Countries: CANADA, UNITED STATES **Document ID:** IK1201453
Availability: Fleet/SIS, Is/SIR **Revision:** 6
Major System: ENGINES **Created:** 12/1/2020
Current Language: English **Last Modified:** 12/11/2020
Other Languages: NONE **Author:** Greg Scheff
Viewed: 171

Title: New 7095496C3 EGR Bellows Heat Shield ID

Applies To: All A26 Engines

Figure #2: New 7095496C3 Heat Shield

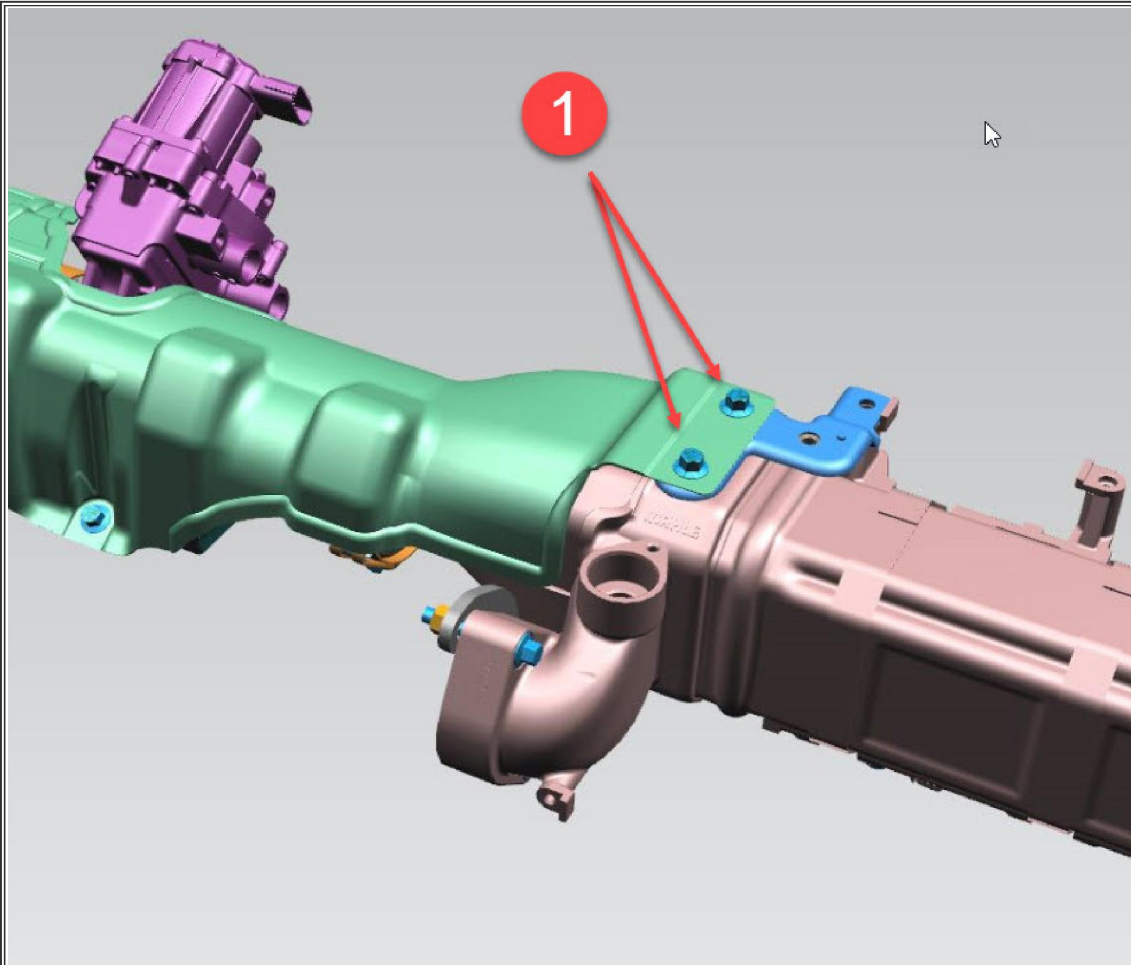
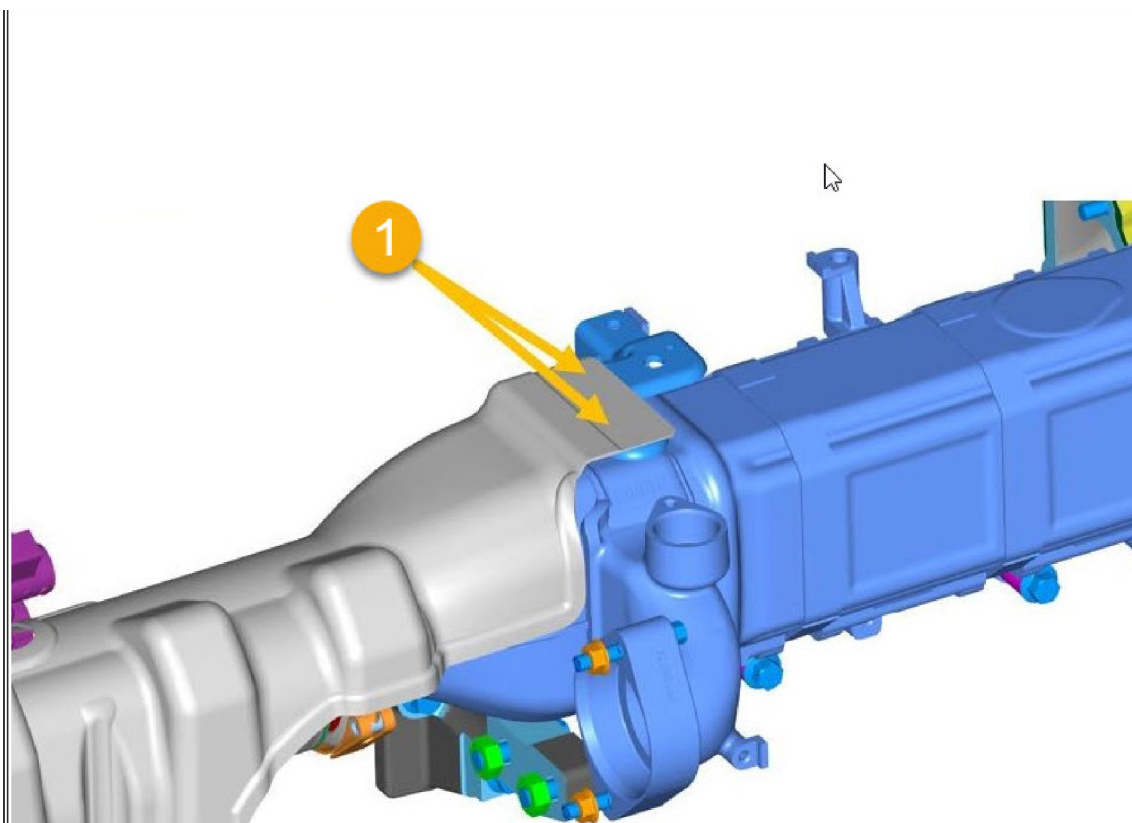
The new 7095496C3 heat shield is the same physical size but will be missing two bolt holes that were present on the former heat shields.

Item 1: Two 7096346C1 mounting bolts at the top of the EGR cooler

1. The former heat shields had two bolts securing the shield at the top of the EGR cooler assembly (Figure #1, Item 1).

Item 1: Two bolt holes no longer present

2. The new 7095496C3 heat shield no longer requires fasteners at the front of the heat shield so no holes are present (Figure #2, Item 1)

3. Leave the existing bracket in place that the former heat shield fastened to at the top of the EGR cooler. Install the new heat shield and torque all four of the 7096346C1 fasteners to 13 lb-in (18 N.m) as outlined in the [SERVICE MANUAL](#).
